City of Detroit
Inter-Departmental Communication

RE: Petition No. 486
Requested Berm Parking Into Waltham at 12700 East Eight Mile.

PROVISIONS FOR ENCROACHMENT For Petition 486

**REQUEST BERM USE
 (For Parking Only)
 INTO WALTHAM AVE.
 AT 12700 E. EIGHT MILE RD.**

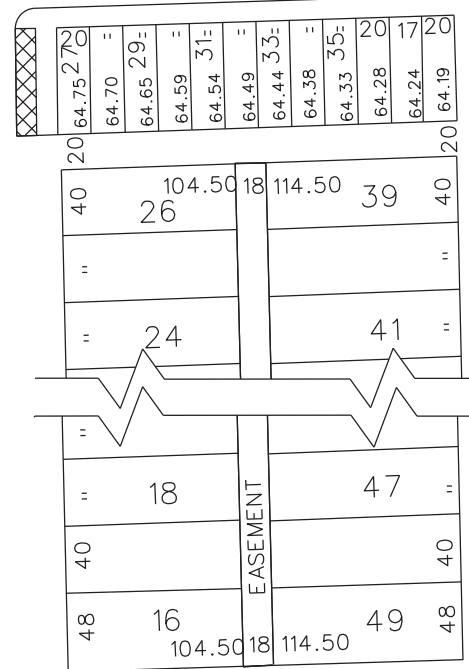
- Our records show that there is a sewer in the vicinity of the area requested for berm parking. However, DWSD has no objection to the use of the berm for parking provided that the petitioner follows the attached Provisions for Encroachment.
